Field campaign

Topic	Software update for the rear door control modules - 00BB and 00BC during PDI (SC23/24)
Market area	Australia E04 Bentley rest Asia and Australia (6E04),China 723 Volkswagen (Anhui) Automotive CO (6723),China 796 VW Import Comp. Ltd (Vico), Beijing (6796),Germany E02 Bentley rest Europe (6E02),Japan E03 Bentley Japan (6E03),Korea, (South) E08 Bentley South Korea (6E08),United Arab Emirates E06 Bentley Middle East and Africa (6E06),United Kingdom E01 Bentley UK (6E01),United States E05 Bentley USA and rest America (6E05)
Brand	Bentley
Transaction No.	2071260/4
Campaign number	EC89
Note	
Type	
US code

New Continental GT and New Continental GTC

Software update to the rear door control modules 00BB and 00BC - Short drop function elimination

Figure 1

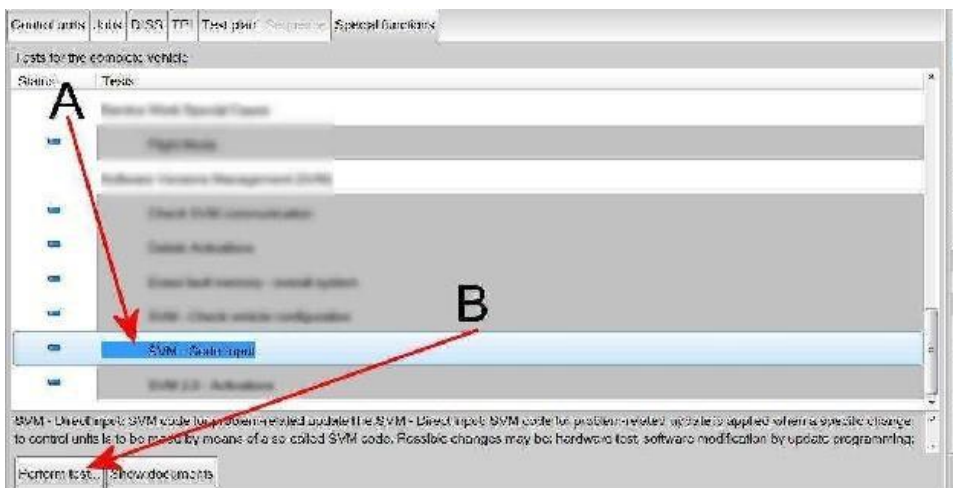
1) Referring to Figure 1 - Within the Special functions tab - Select SVM - Code Input (Point A)

• Select Perform test (Point B)

Figure 2

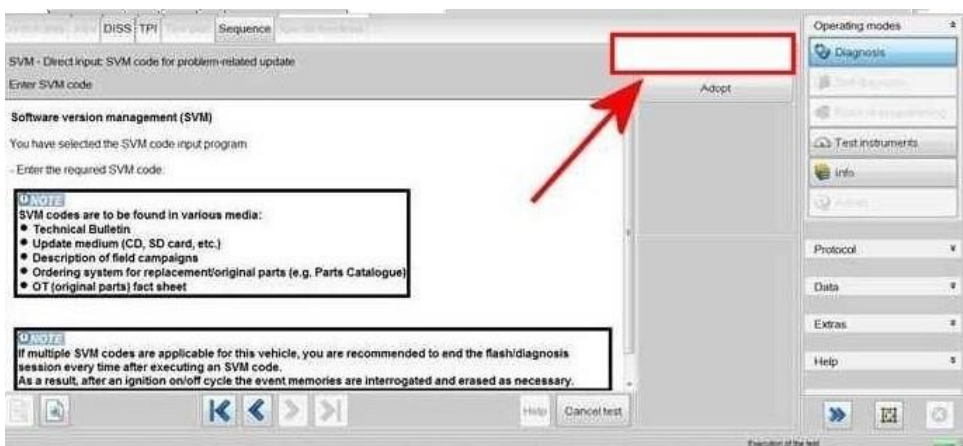
2) Referring to Figure 2 - Enter the SVM code 370WAD01
